# Access Compliance Report

## Public Rights-of-Way

Intersection ID: 10034592	Main Street: PIPER_STATION_DR	Cross Street: N/A	Location: SE
ADA ID: 01E388CB0072	Ramp Type: BlendTrans1	Initial Pass/Fail: Pass	Overall Compliance: No
		Severity Score: 0.25	
Codes/Mitigation Info/Possible Solution		Field Measurements/Component Compliance

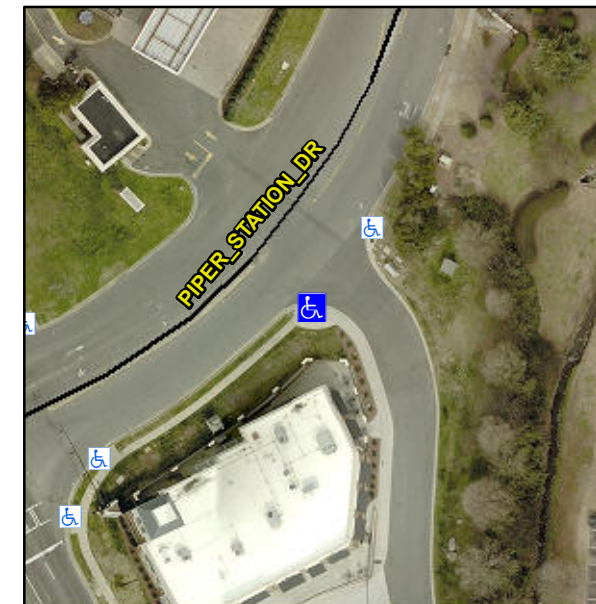
**R304.5.3, R304.2.2-Perp, R304.3.2-Para**

Compliance	Description	Data	Compliance	Description	Data
N/A	Ramp Length (in)	65.5	Yes	BlendTrans Slope (%)	4.3
Yes	Ramp Width (in)	48.0	No	BlendTrans XSlope (%)	2.8
N/A	Flare Type LT	Sloped	N/A	Flare Type RT	Sloped
Yes	Flare Slope LT (%)	2.2	N/A	Flare Slope RT (%)	9.0
N/A	Flare Traversable LT?	Yes	N/A	Flare Traversable RT?	No
Yes	Landing Length (in)	60.0	Yes	DWS Provided?	Yes
Yes	Landing Width (in)	48.0	Yes	DWS Contrast?	Yes
No	Landing Slope (%)	2.8	Yes	DWS Length (in)	24.0
No	Landing X Slope (%)	3.0	Yes	DWS Full Width?	Yes
N/A	Landing Curb? (Y/N)	No	Yes	DWS Offset (in)	1.0
N/A	Shared Landing?	No			
Yes	Gutter Ponding?	No	Yes	Gutter Slope (%)	1.8
Yes	Gutter Lip Ht (in)	0.0	Yes	Gutter X Slope (%)	0.5
N/A	Painted X Walk1?	No	N/A	Painted X Walk2?	No
	X Walk 1 Direction	To NE		X Walk 2 Direction	To NW
	X Walk 1 Width (in)	N/A		X Walk 2 Width (in)	N/A
	X Walk 1 Slope (%)	3.1		X Walk 2 Slope (%)	3.9
	X Walk 1 X Slope (%)	0.1		X Walk 2 X Slope (%)	2.7

**Remove & Replace Curb Ramp With Two New Directional Ramps or Equivalent.**
